Lincoln Property  
c/o  
Paul Shadle  
DLA Piper LLP  
444 West Lake Street  
Suite 900  
Chicago, IL 60606

May 18, 2021

### **COMPREHENSIVE FEEDBACK**

The following schematic of a potential stepped-shape building was provided:

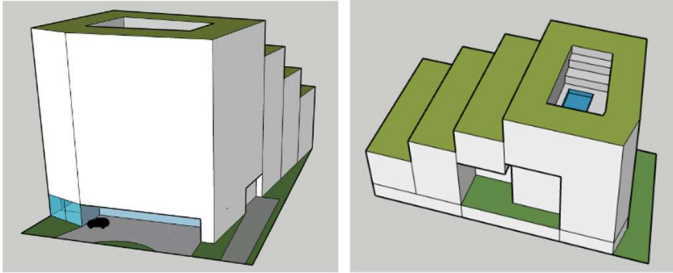
- I would prefer a taller building that would be on the eastern part of the lot—if it would help keep partial lake views for the existing buildings that would be blocked with the current plan. If you did a gradual increase of building size from the western corner to the eastern corner, you could stair-step up each section by a few stories. Each stair stepped rooftop could be a green roof or even terrace space for residents so that the residents had a pleasant view from their units.

- Stepped shaped building.
- It is so ugly, a cross between an ice tray and a lego brick. If it has to be there can't it be beautiful?
- Not overcrowding other buildings
